Connection diagram of connector -TMDS 181

Evaluation is underway at TI - TMDS181RGZEVN.

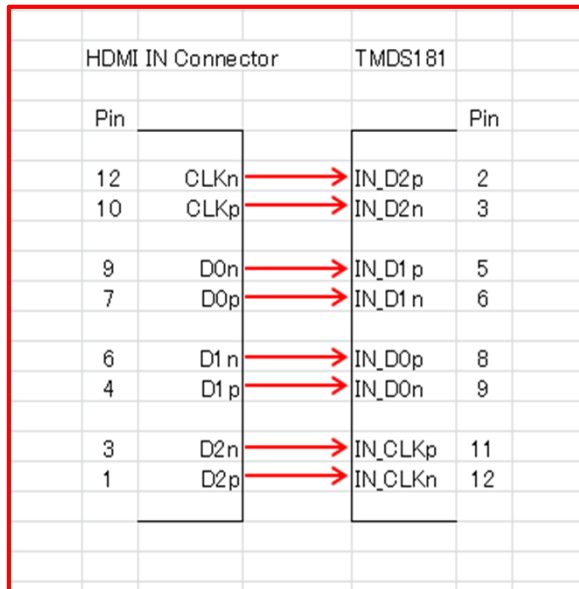
As a result of the following procedure, the Lane Swap bit (09h bit 7) does not become "1".

Procedure

1: SWAP/POL(1pin): "H" fixed.

2: Device power on

3: I2C control: Set to Retimer mode (0Ah: 1:0 → "11")

Are there any mistakes in the procedure?

When swapping lanes and polarities, please tell me the order of setting.

Is TMDS 181 correspondence of replacing only one side of lane and polarity?

(Is it impossible to exchange both?)
